Project Name: Brandon Big Room Renovations

Project Number: 24-040

ADDENDUM NO. 2

ITEM NO. 5 D100 DEMOLITION PLAN

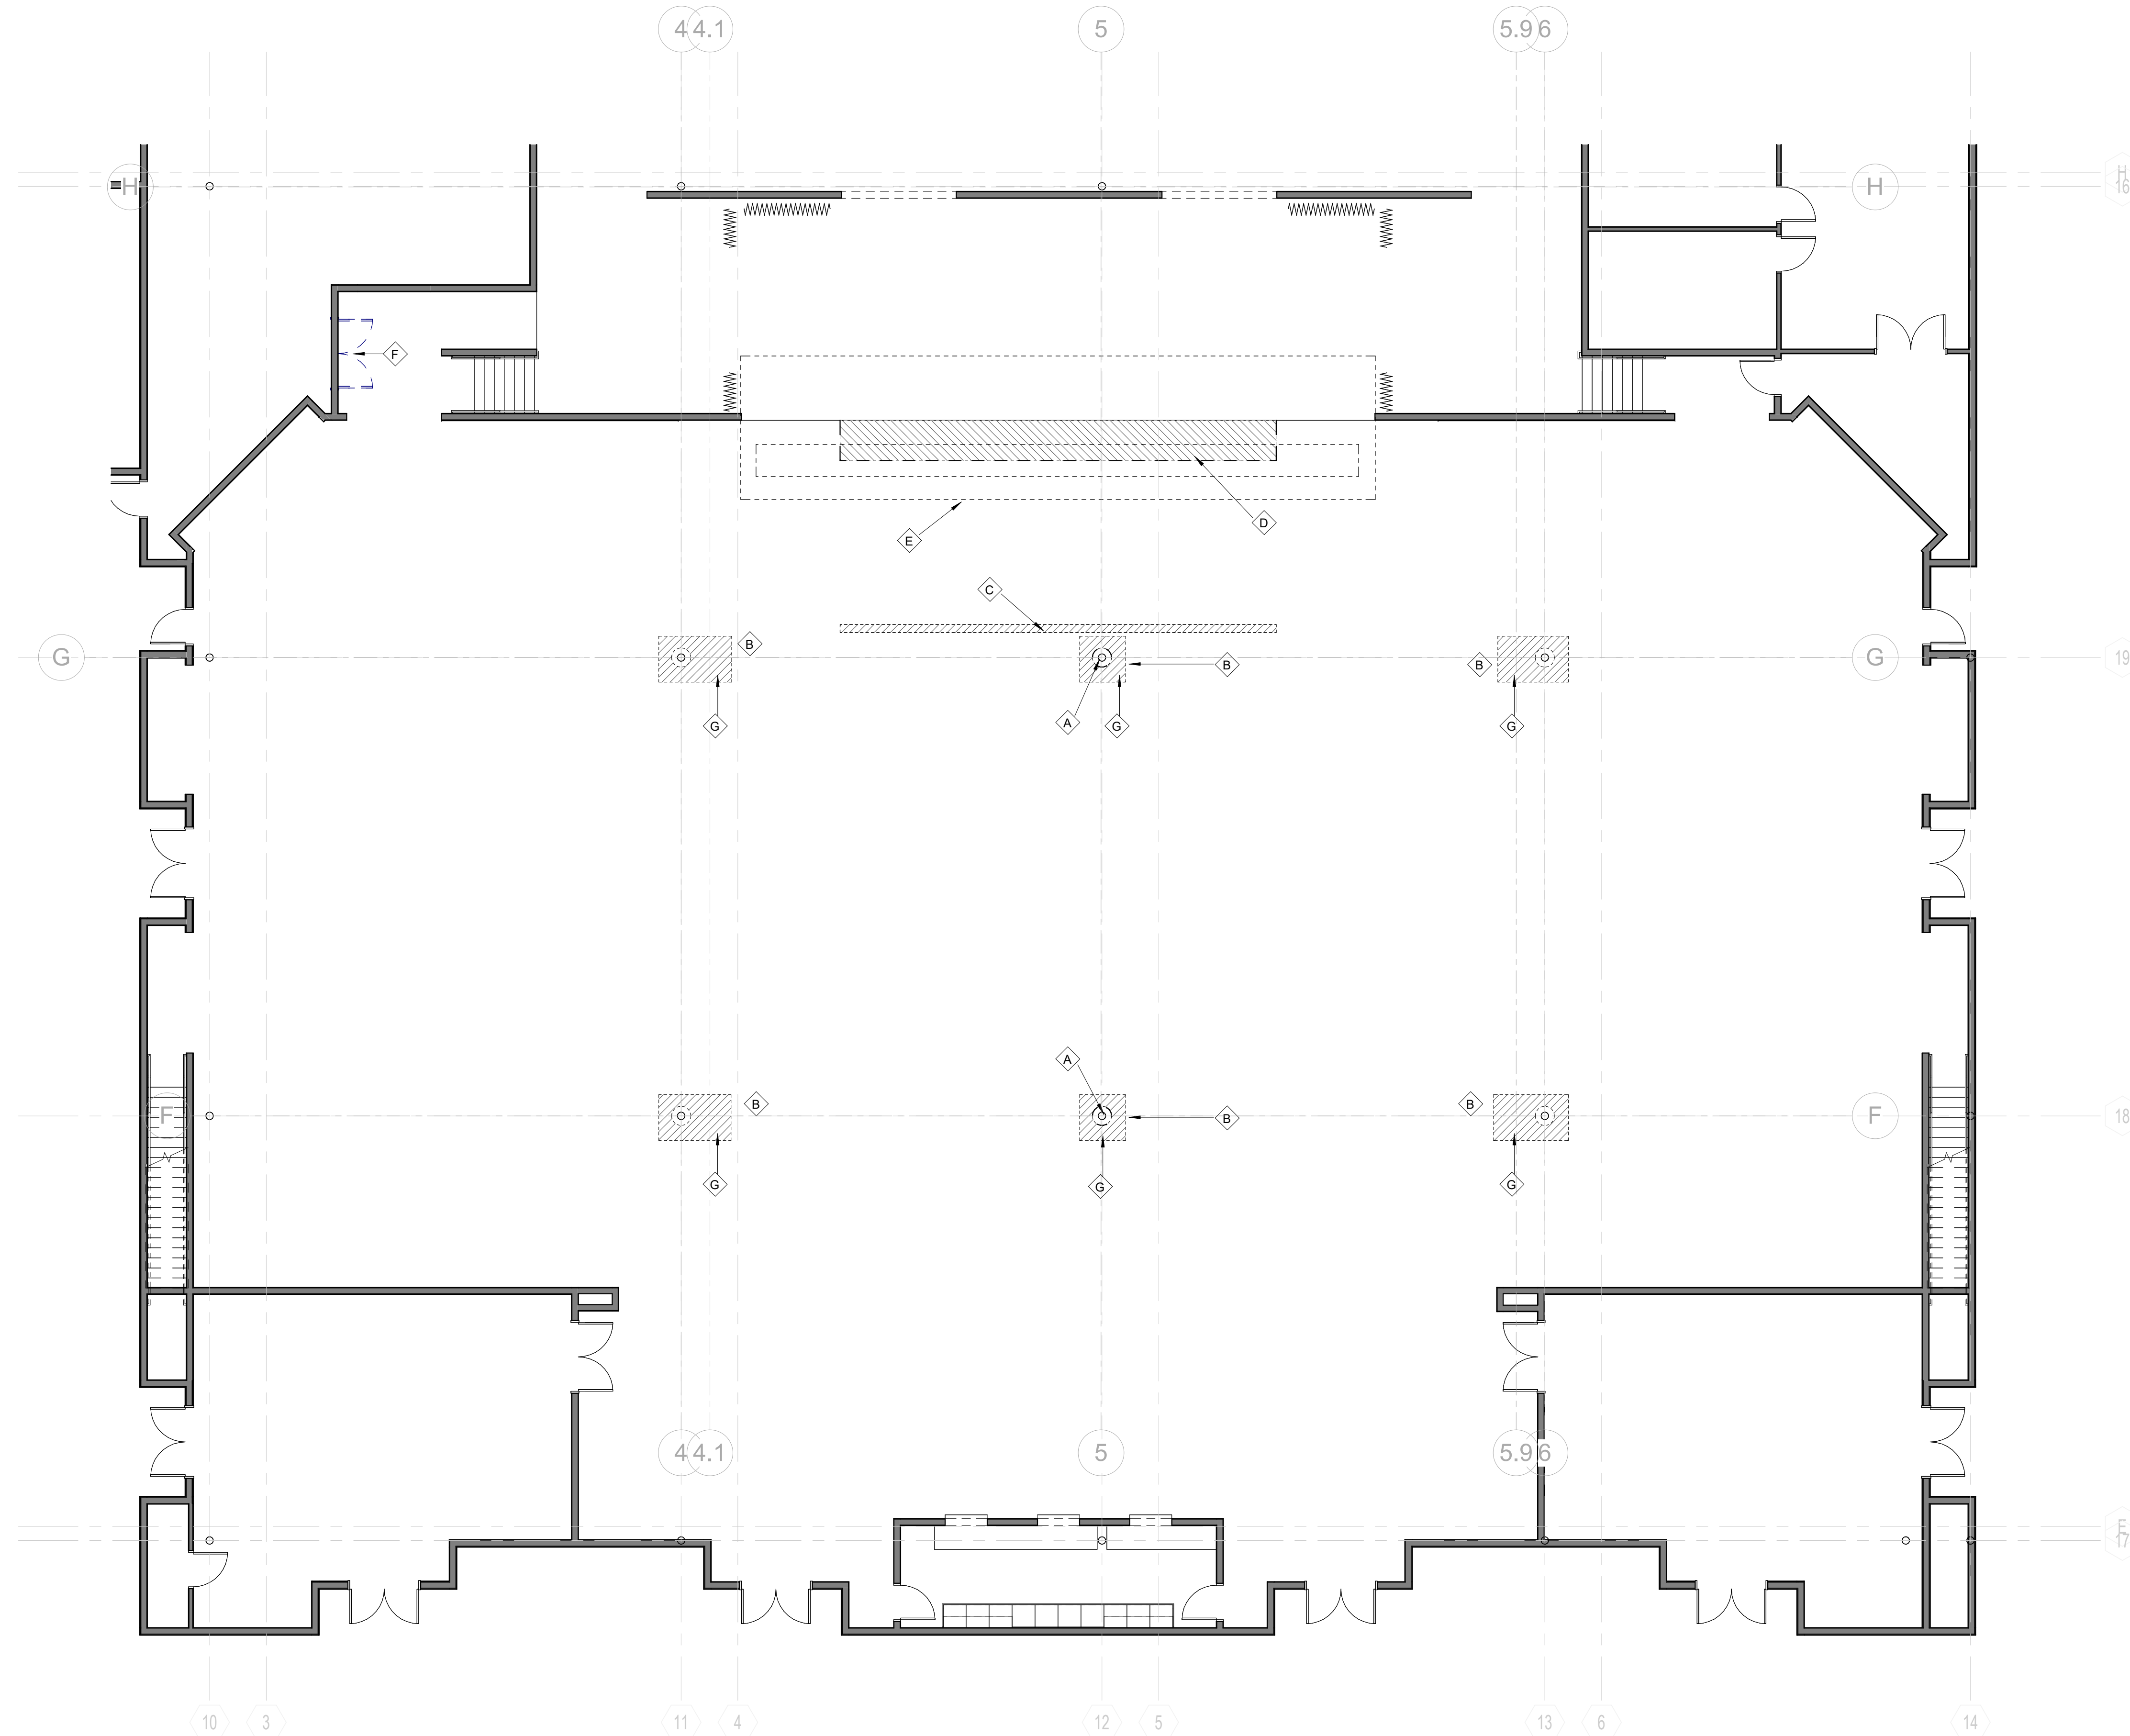
Revise per the enclosed sheet.

Keyed Note “D” revised.

- A. EXISTING COLUMNS TO BE CUT AFTER NEW TRUSS INSTALLATION. (SEE STRUC.)
- B. EXISTING CARPET TO BE REMOVED AROUND COLUMNS AS NEEDED
- C. SALVAGE STAGE LIGHTS AND TV'S (ABOVE), PROTECT FOR RE-INSTALLATION
- D. DEMOLISH EXISTING SPEAKER HOUSING CONSTRUCTION. SALVAGE ALL SPEAKERS AND SMALL COVERS. PROTECT FOR REINSTALLATION.
- E. DEMO GYP. BOARD "EYEBROW" (ABOVE STAGE); REPAIR SIDE WALLS AS NEEDED W/ GYP. BD. (PAINT TO MATCH EXISTING)
- F. SALVAGE EXISTING DOOR AND FRAME FOR RE-INSTALLATION. OPENING TO BE INFILLED W/ CFS FRAMING AND GYP. BOARD (PAINT TO MATCH EXISTING)
- G. SAW CUT AND DEMO PORTION OF EXISTING SLAB AROUND COLUMN BASE AS NEEDED FOR COLUMN REMOVAL AND NEW COLUMN INSTALLATION

1 FIRST FLOOR PLAN ADDITION
1/8" = 1'-0"

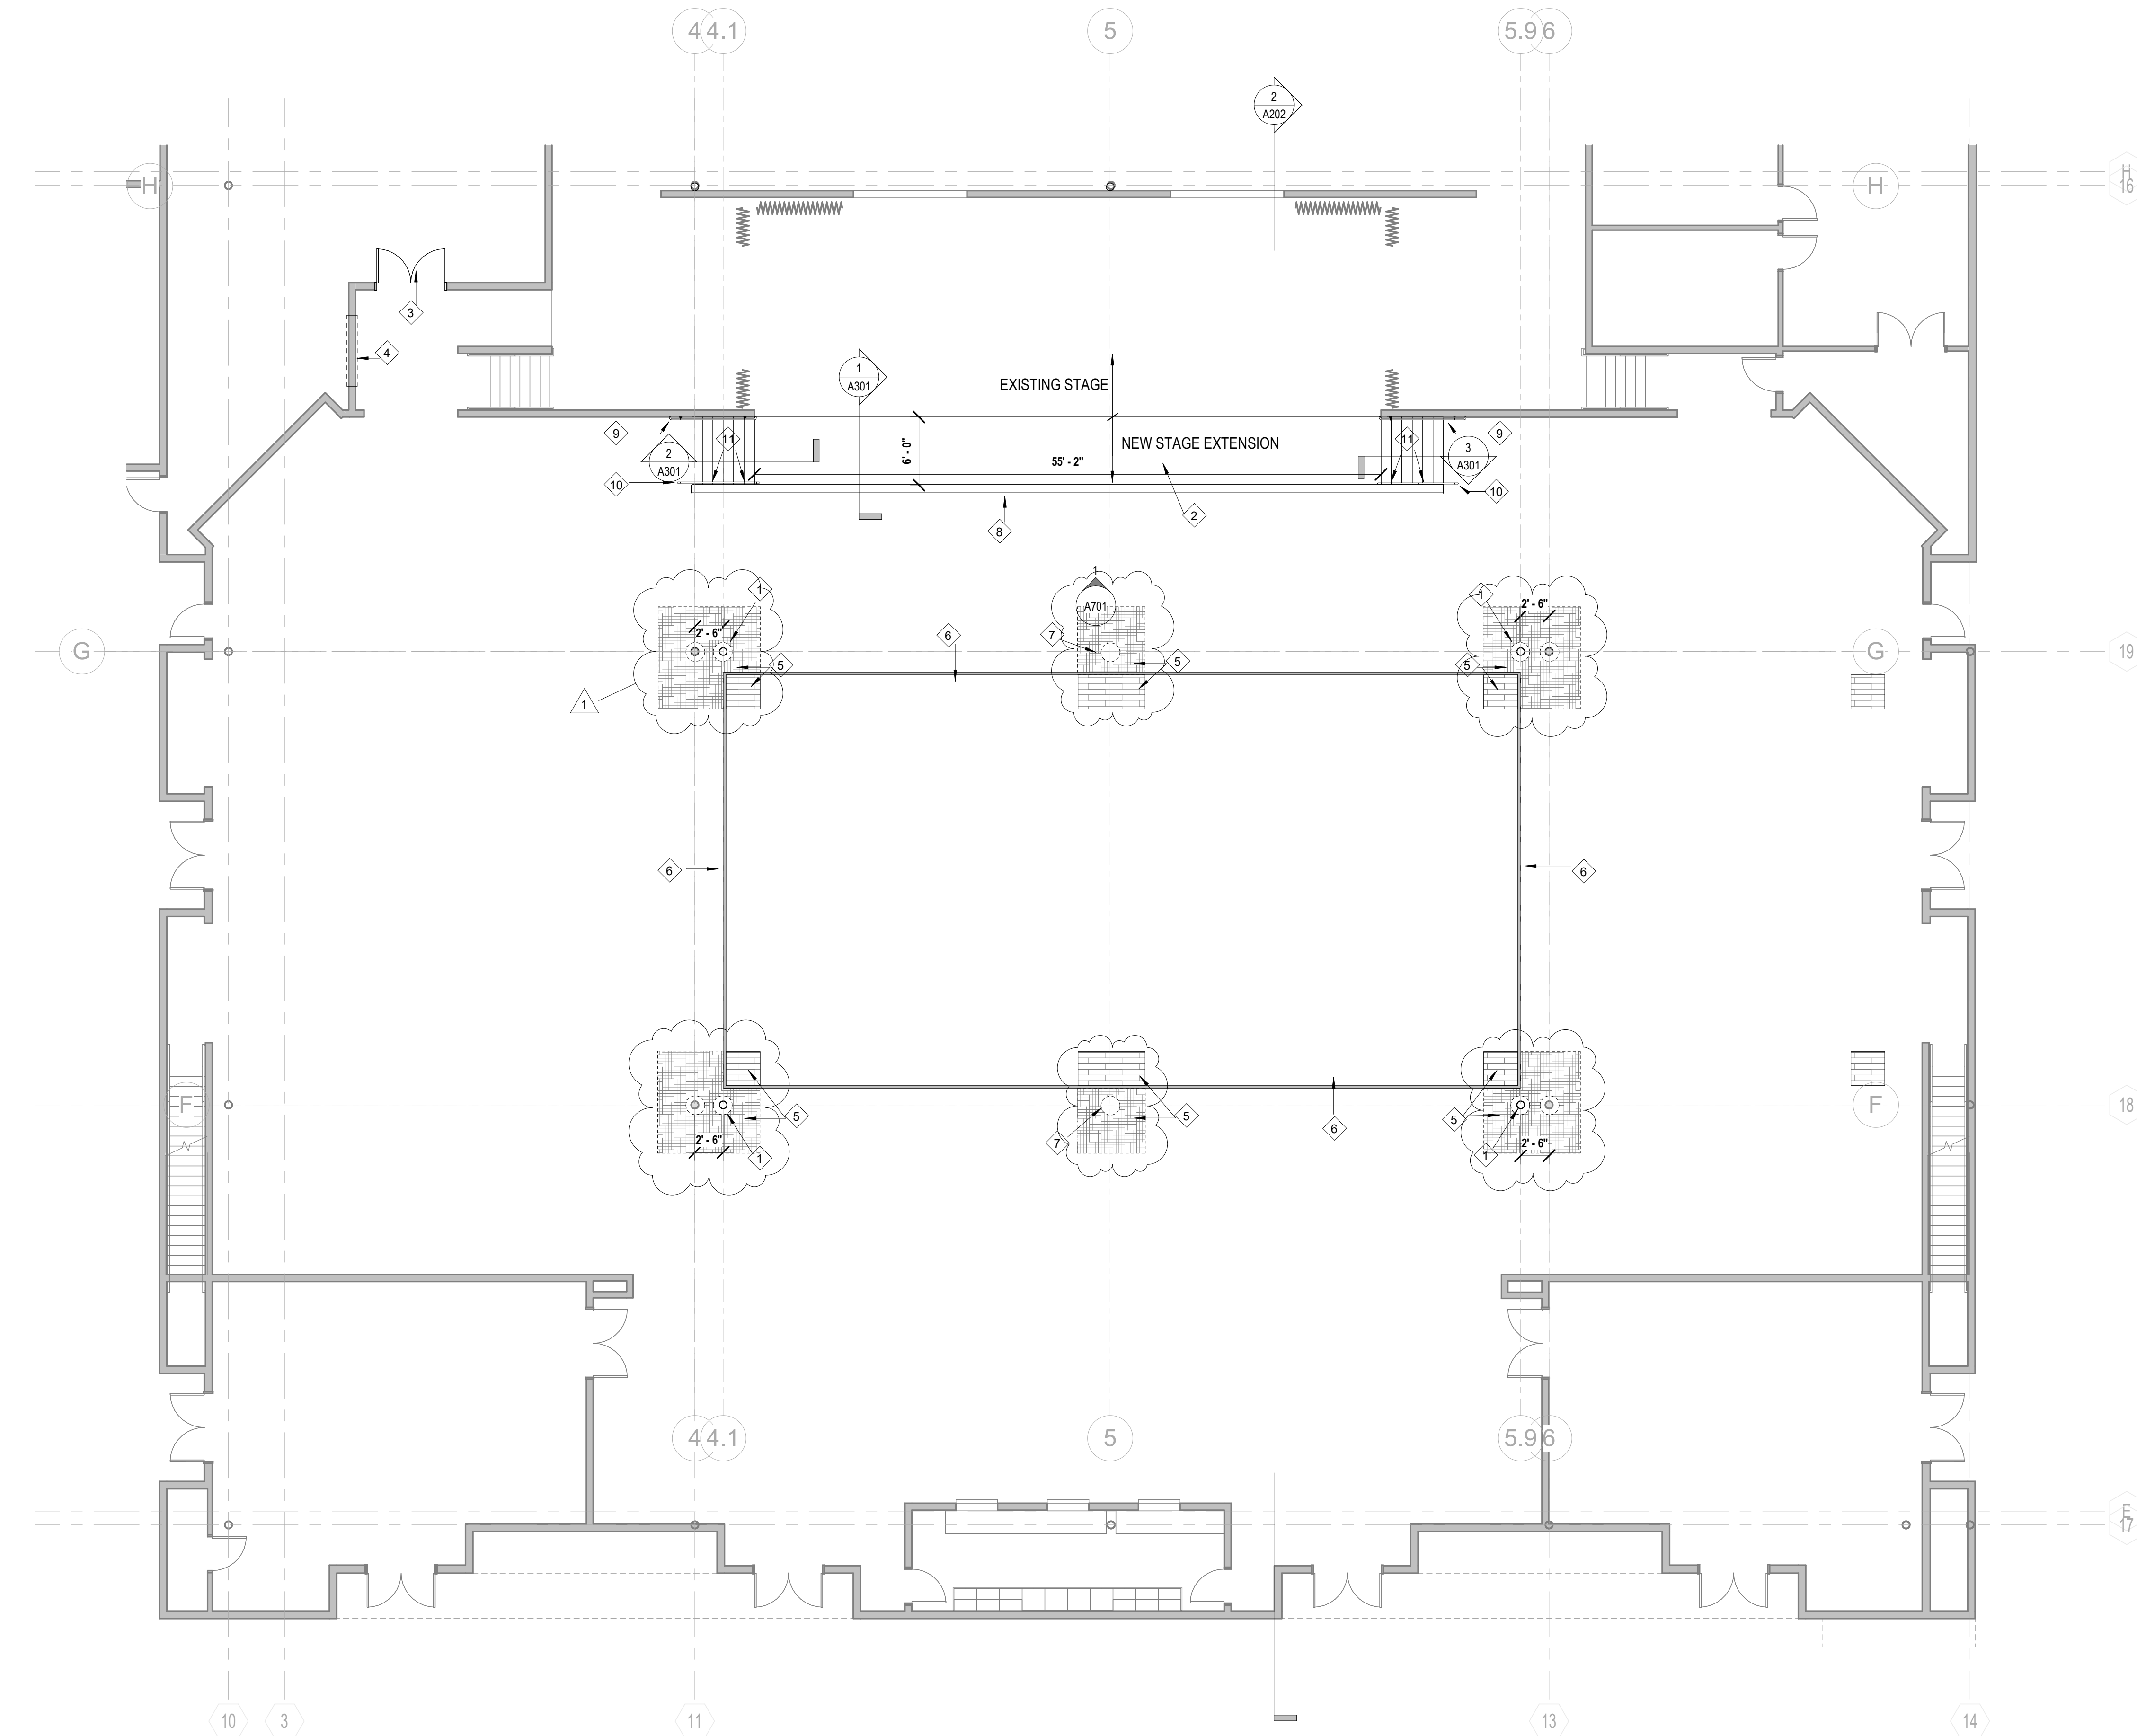
ITEM NO. 6 A101.1 FLOOR PLAN ADDITION

Revise per the enclosed sheet.

Keyed Notes "2" & "5" revised

- 1 NEW COLUMNS TO BE INSTALLED; SEE STRUC.
- 2 NEW 6' STAGE EXTENSION W/ NEW WD FLOORING TO MATCH EXISTING
- 3 EXISTING DOOR AND FRAME TO BE RE-INSTALLED
- 4 OPENING TO BE INFILLED W/ CFS FRAMING AND GYP. BOARD; PAINT TO MATCH EXISTING; ADD WALL BASE TO MATCH EXISTING
- 5 NEW CARPET / TILE MATERIAL FOR PATCHING AND REPAIRS AS NEEDED.
- 6 REPAIR RUBBER TRANSITION STRIP AT DANCE FLOOR AS NEEDED
- 7 REINFORCE CONCRETE SLAB, INFILL TO MATCH EXISTING
- 8 NEW WD. WALL BASE AT STAGE EXTENSION; MATCH EXISTING PROFILE (PAINT)
- 9 STL. WALL MOUNT RAILING
- 10 STL. FLOOR MOUNT RAILING
- 11 WALL-MOUNTED STAIR GRILL LIGHTS (SEE ELEC.)

1 INTERIOR ELEVATION
3/8" = 1'-0"

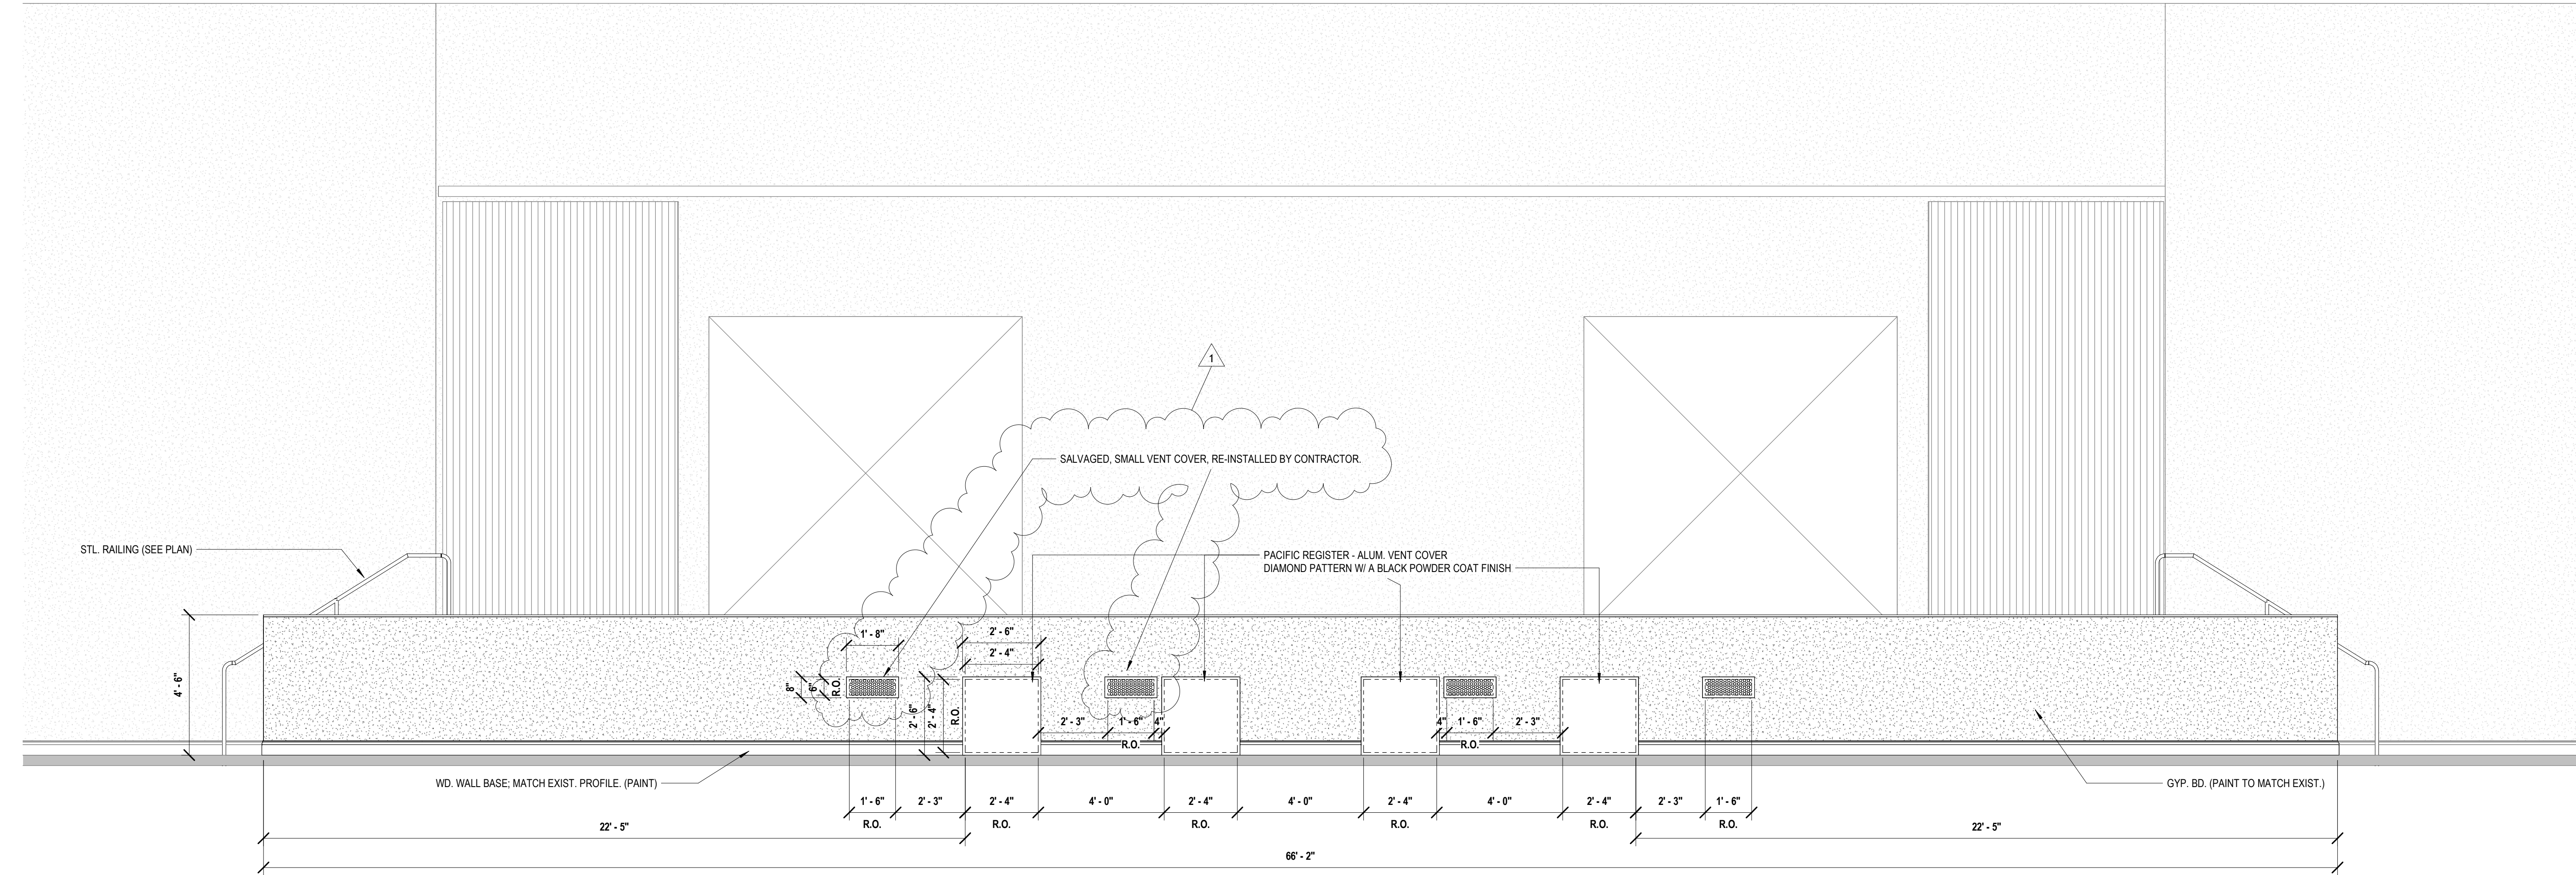
ITEM NO. 7 A701 INTERIOR ELEVATIONS & DETAILS

Revise per the enclosed sheet.

Elevation notes revised
